ADDENDUM NO. 2
TO THE CONTRACT DOCUMENTS
for the construction of

Date: 6/18/18
Project No.: 691778

SHAMROCK, BLALOCK & HOOPER RESERVOIRS – WATER QUALITY IMPROVEMENTS

CLAYTON COUNTY WATER AUTHORITY
CLAYTON COUNTY, GEORGIA

05-Y-206

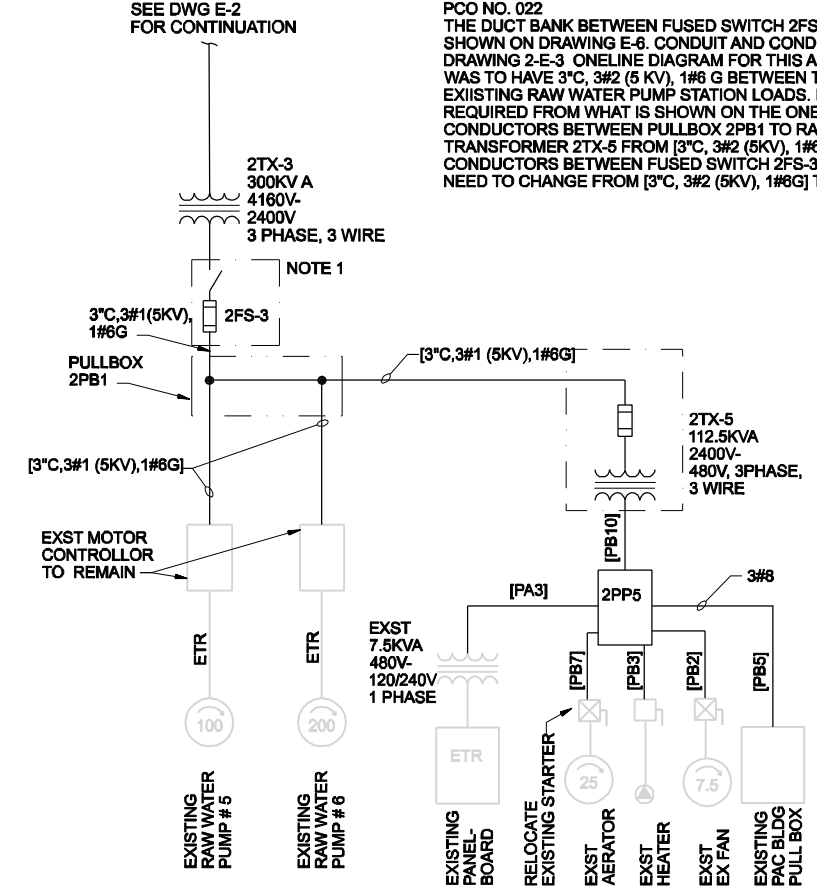
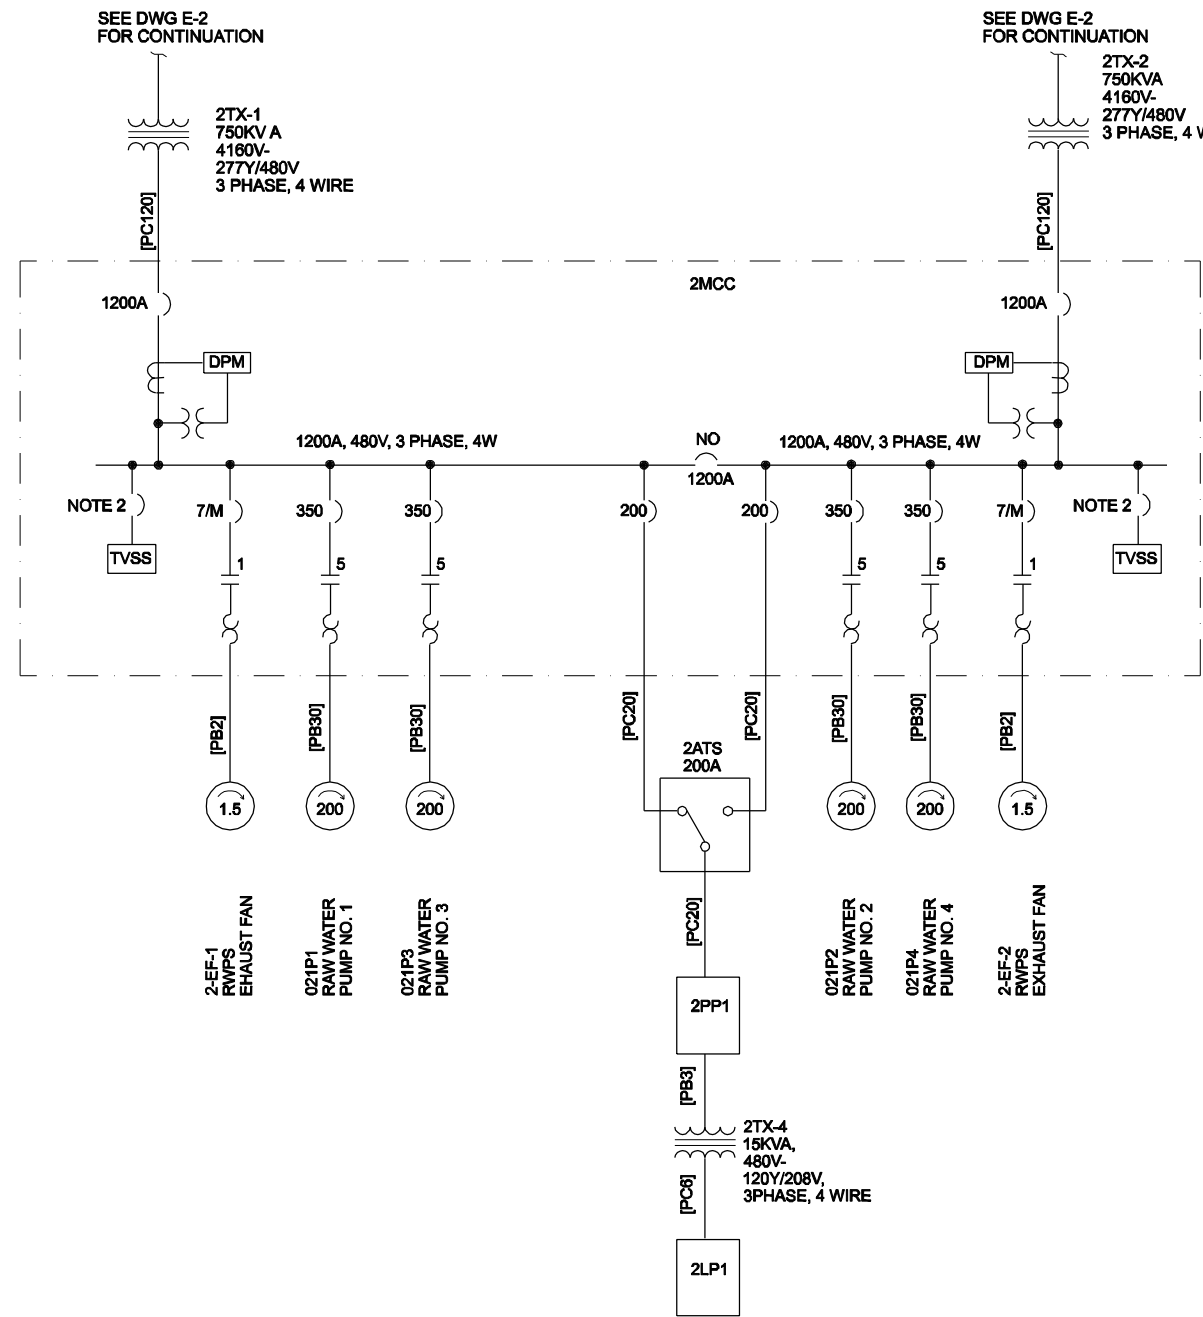
15. Keynote 3 on drawing 15-E-201 references “existing panel 020-CP located in the Raw Water Pumping Station Electrical Room. See Site Plan.” This building and panel is not shown/labeled on the drawings. Please provide location of Raw Water Pumping Station Electrical Room and panel 020-CP.

Raw water pump station label added on sheet 05-Y-206. See attached reference documents for location of electrical room and panel 020-CP.

DWG	2-E-4
DATE	APRIL 2003
PROJ	169760.CD

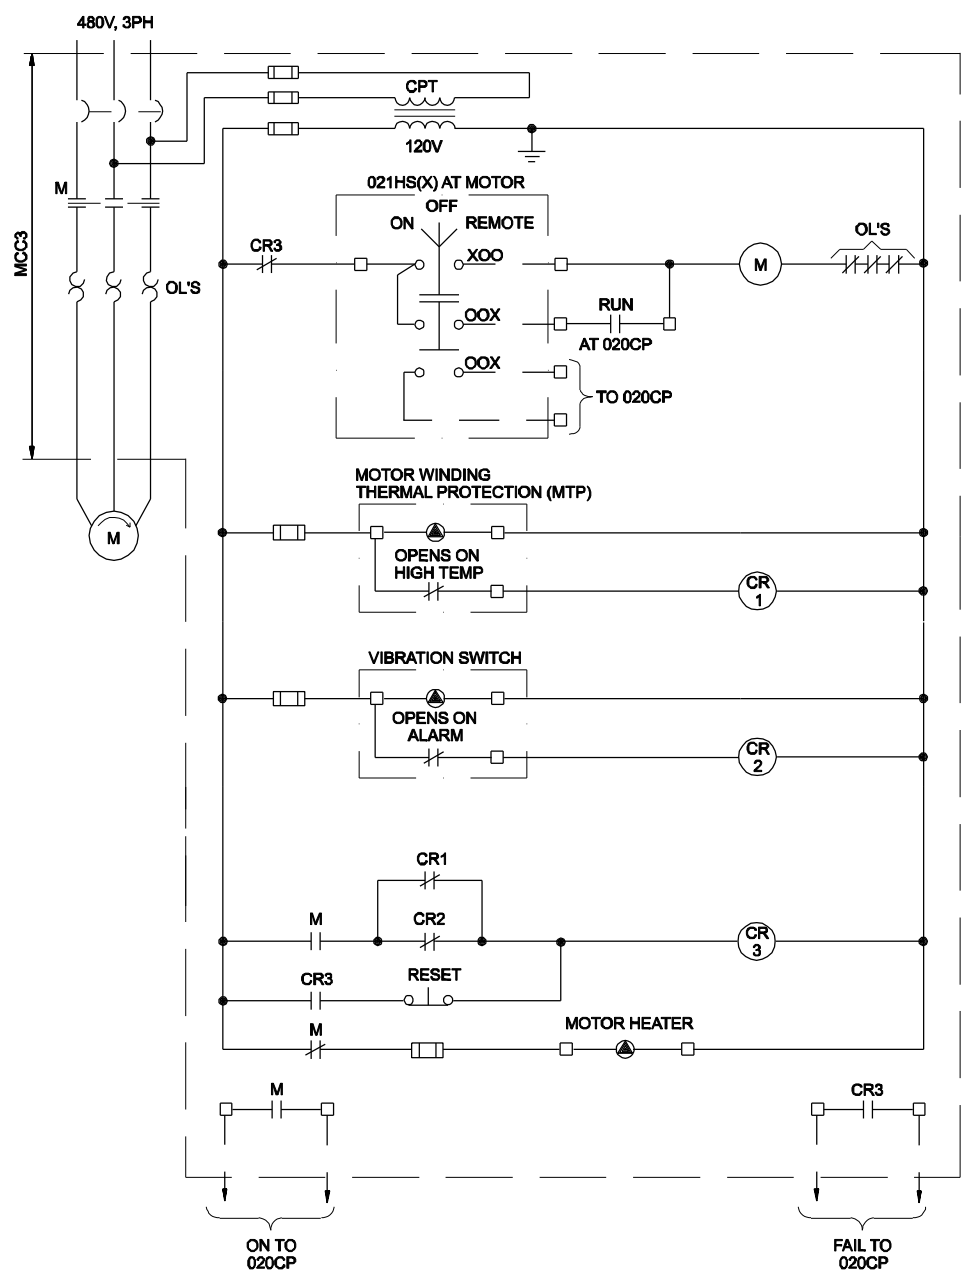
PCO NO. 022
 THE DUCT BANK BETWEEN FUSED SWITCH 2FS-3 AND PULLBOX 2PB1 IS NOT SHOWN ON DRAWING E-6. CONDUIT AND CONDUCTORS ARE SHOWN ON DRAWING 2-E-3 ONELINE DIAGRAM FOR THIS AREA. THE DESIGN INTENT WAS TO HAVE 3" C, 3#2 (5 KV), 1#6 G BETWEEN THE FUSED SWITCH AND ALL EXISTING RAW WATER PUMP STATION LOADS. HOWEVER A CHANGE IS REQUIRED FROM WHAT IS SHOWN ON THE ONELINE DIAGRAM. CHANGE CONDUCTORS BETWEEN PULLBOX 2PB1 TO RAW WATER PUMPS AND TRANSFORMER 2TX-5 FROM [3" C, 3#2 (5KV), 1#6G] TO [3" C, 3#1 (5KV), 1#6G]. CONDUCTORS BETWEEN FUSED SWITCH 2FS-3 AND PULLBOX 2PB1 ALSO NEED TO CHANGE FROM [3" C, 3#2 (5KV), 1#6G] TO [3" C, 3#1 (5KV), 1#6G].

DWG	50-E-3
DATE	APRIL 2003
PROJ	169760.CD

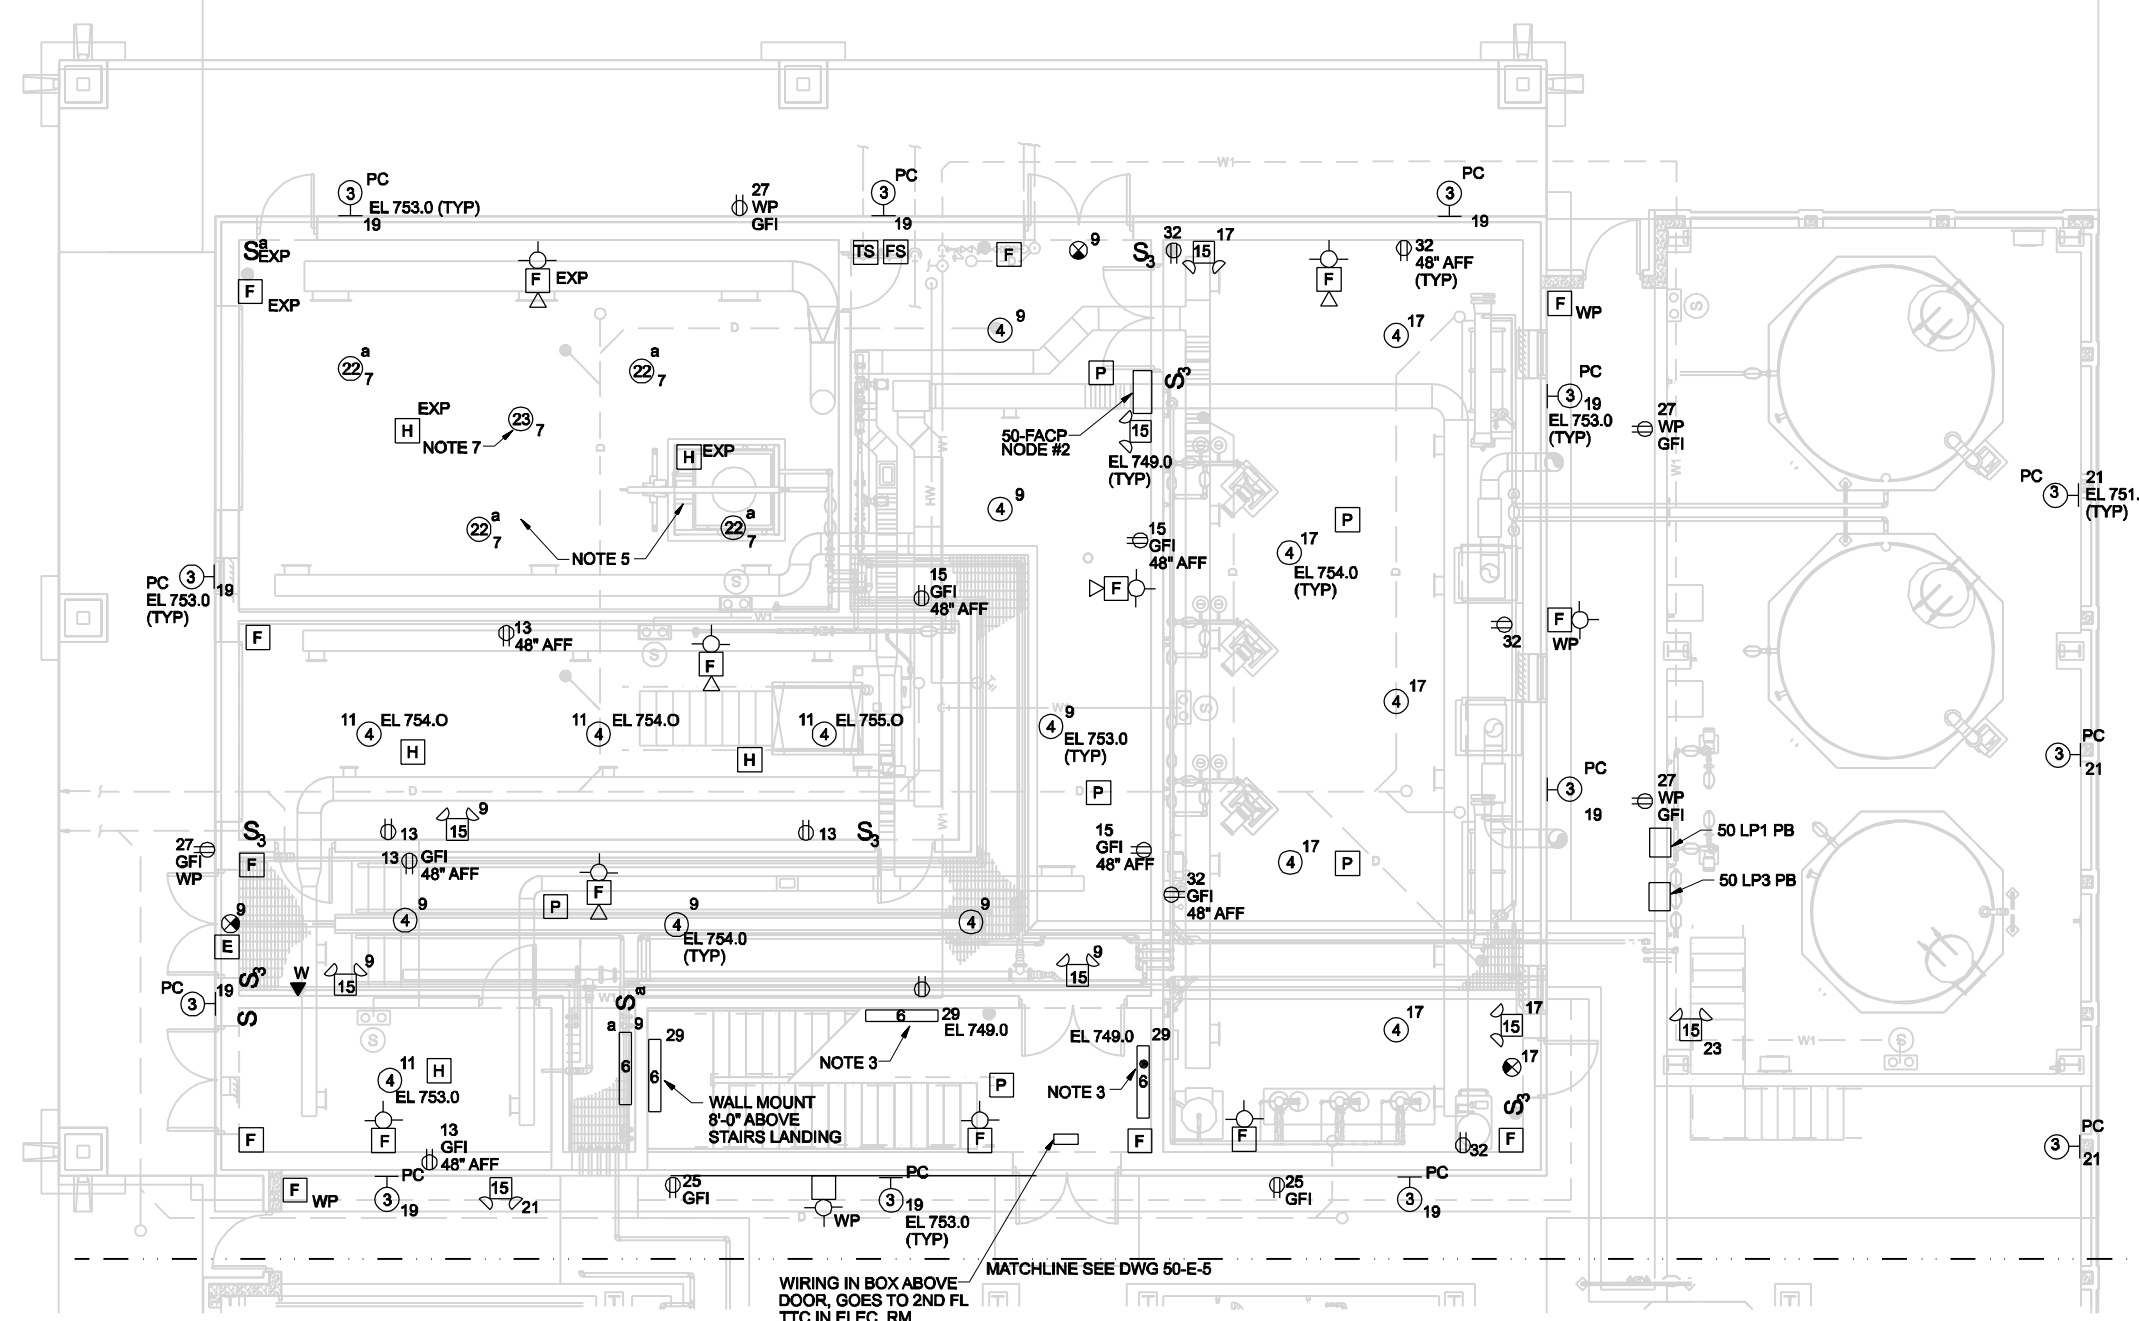
FIELD ORDER NO. 015:
ON DRAWING 50-E-4, IN THE PAC ROOM TWO (2) EXPLOSION PROOF
RECEPTACLES ARE SHOWN ON THE NORTH AND SOUTH WALLS.
SPECIFICATION SECTION 16050 DOES NOT LIST EXPLOSION
PROOF RECEPTACLES. DELETE THESE RECEPTACLES.

DWG	50-E-6
DATE	APRIL 2003
PROJ	169760.CD

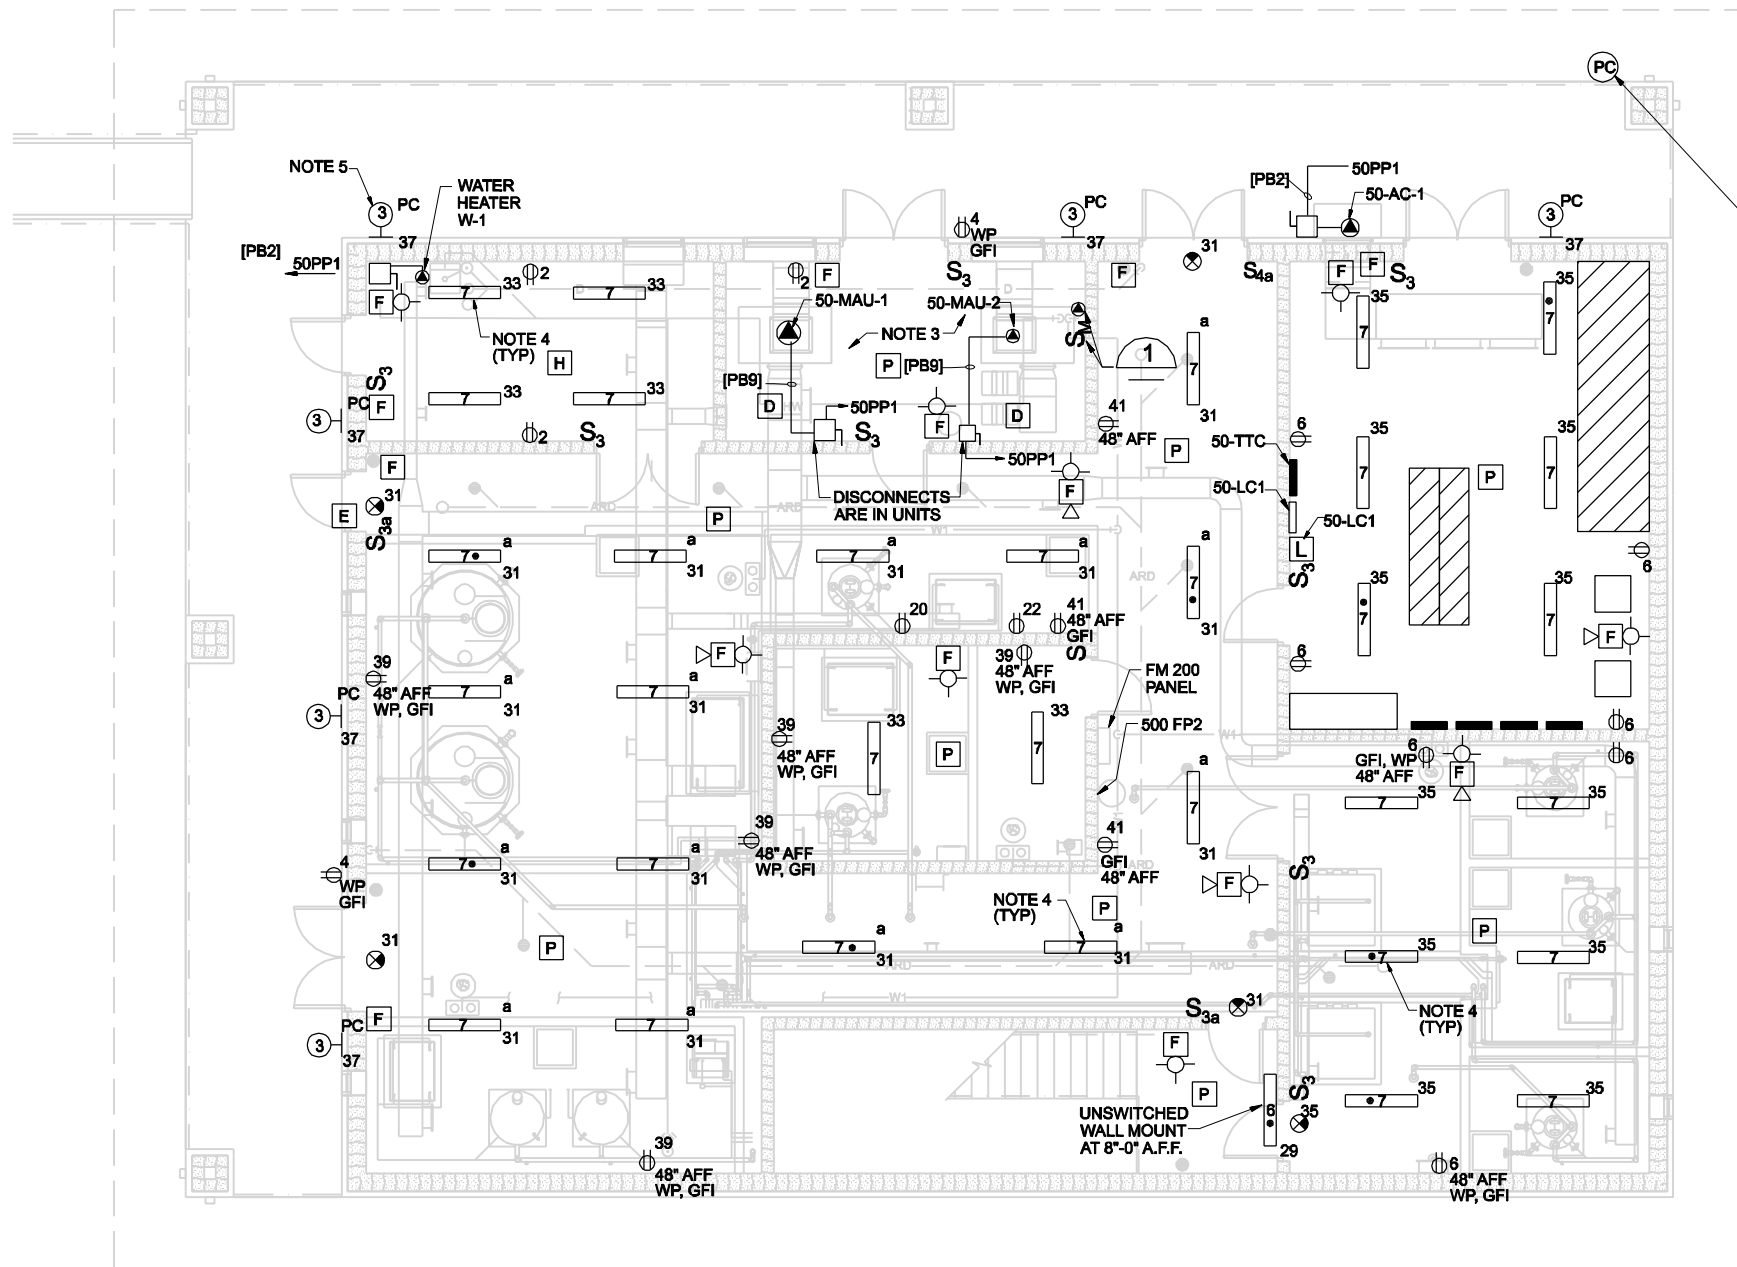
THE WATER HEATER POTENTIALLY CONFLICTS WITH THE DUCTWORK FOR 50-MAU-2 AND THE FIRE SPRINKLER FEED FROM THE FIRST FLOOR. ON DRAWING 50-P-2, RELOCATE THE WATER HEATER FROM THE MECHANICAL ROOM (ROOM 50-203) ON THE SECOND FLOOR TO THE MAINTENANCE ROOM (ROOM 50-207). INSTALL WATER HEATER JUST WEST OF SINK SSK-1 AND ROUTE HIGH PRESSURE RELIEF VALVE PIPING INTO SSK-1. ON DRAWING 50-E-6, RELOCATE THE HOT WATER BOOSTER PUMP SHOWN IN DETAIL 1 TO THE MAINTENANCE ROOM ALONG WITH THE HOT WATER HEATER. RELOCATE CORRESPONDING CIRCUITS FOR THE WATER HEATER AND BOOSTER PUMP. CONVERT ADJACENT DUPLEX RECEPTACLE IN MAINTENANCE ROOM TO GFI TYPE.

- (110) THE WATER HEATER FOR CHEMICAL BUILDING DOES NOT REQUIRE A RECIRCULATING BOOSTER PUMP SYSTEM. THE POWER REQUIREMENT FOR THE ELECTRIC WATER HEATER NEEDS TO BE RELOCATED.

FIELD ORDER NO. 004, DECEMBER 08, 2003: CHANGE PANEL TAGGED "500FP2" SHOWN OUTSIDE FLUORIDE PUMP ROOM TO "FM200 FIRE SUPPRESSION SYSTEM PANEL"

CCIR NO. 013
ON 50-E-8, TRANSFORMER 50TX5 WAS ADDED AS A RESULT OF ADDENDUM #3. DRAWING 50-E-6 DOES NOT SHOW THE LOCATION FOR TRANSFORMER 50TX5. THERE SHOULD BE SPACE NEXT TO 50TX3 AND 50TX4 TO SET 50TX5 IF THE TRANSFORMERS ARE MOUNTED CLOSER TOGETHER THEN SHOWN ON DRAWING 50-E-8. THE CONTRACTOR MAY CHOOSE TO MOUNT 50TX5 NEXT TO PANEL 50LP3 IF THIS IS AN EASIER LOCATION, HOWEVER, BE SURE FOUR FEET MINIMUM IS MAINTAINED BETWEEN ANY EQUIPMENT AND THE MCC'S IN THE MIDDLE OF THE ELECTRICAL ROOM.
